DRAWING No. 3435-50-017
REV: A

M2 POWER STATION
UNIT 11 TURBINE COOLING WATER
PIPE W-017 ASSEMBLY

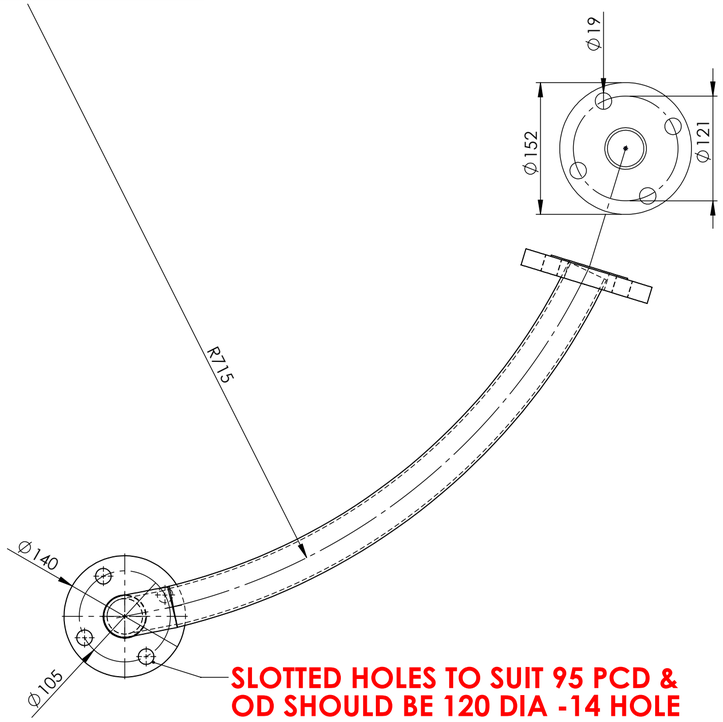
REVISIONS			
REV.	DESCRIPTION	DATE	APPROVED
A	WAS 40NB PLATE FLANGE JIS10 316L S/S	5/02/2025	NDB

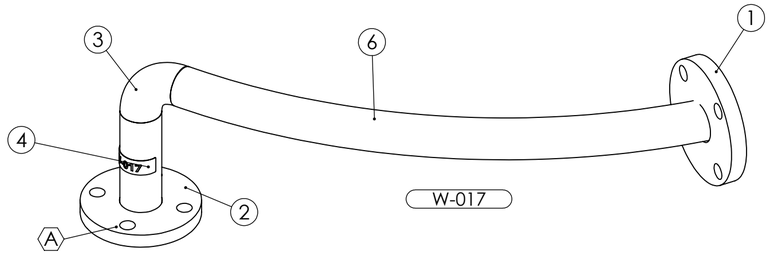
SLOTTED HOLES TO SUIT 95 PCD & OD SHOULD BE 120 DIA -14 HOLE
